SUPPLEMENTARY REPORT

DEVELOPMENT APPLICATION NO.: 213/2025

SUBJECT: Electricity Generating Works & BESS – 170 Hanwood Avenue Hanwood – Response to Planning Panel Deferred Matter

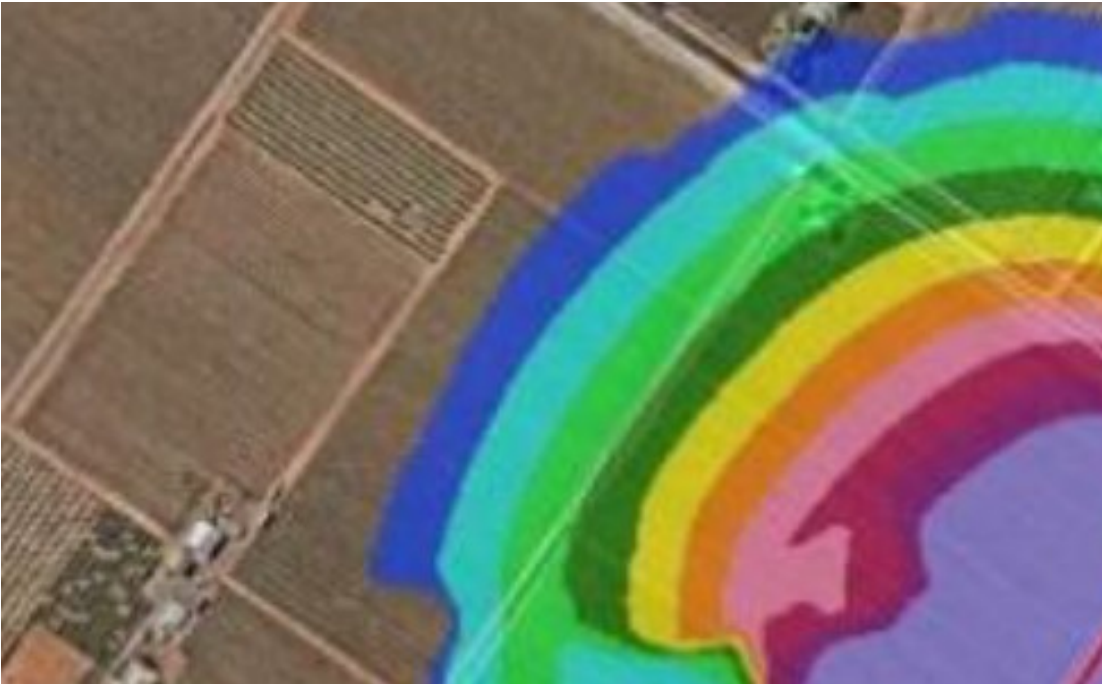
- *Advice from the Applicant's acoustic consultant addressing the extent and appropriateness of the proposed acoustic fencing recommended in the consultant's report of 3 December 2025 at Section at Section 6.3.3 and in Figure 4 (p39). In this respect, the Panel questions the requirement for such fencing to mitigate noise impacts throughout the operational phase of the proposed development, other than to mitigate noise impacts from the proposed BESS. The Panel also requests details of the recommended fencing's material, colour, etc.*
- *The Panel requires the colour of the proposed security fencing to be a black hue in order to reduce its visual impact in the landscape.*
- *The Panel requires details of the measures to be deployed to establish and maintain the proposed screen landscaping throughout the full life of the proposed development.*

The acoustic barriers indicated, if eventually installed, have been positioned within the boundaries of property, following the lease area and would be inside the vegetation screening proposed. This is a change in relation to the northern barrier which was initially illustrated on the Cox Rd frontage of the site.

*An updated Noise and Vibration Assessment prepared by Assured Environmental Pty Ltd provided in **Appendix A**, identifying the re-location of acoustic barriers to within the perimeter security fencing of the development site.*

The acoustic barriers are assumed to consist of a solid, continuous (gap-free) structure and have a minimum surface density of 12.5 kg/m², consistent with standard acoustic barrier design. The barriers will be painted in a green colour to visually mitigate its appearance and to blend in with the proposed vegetation screening.
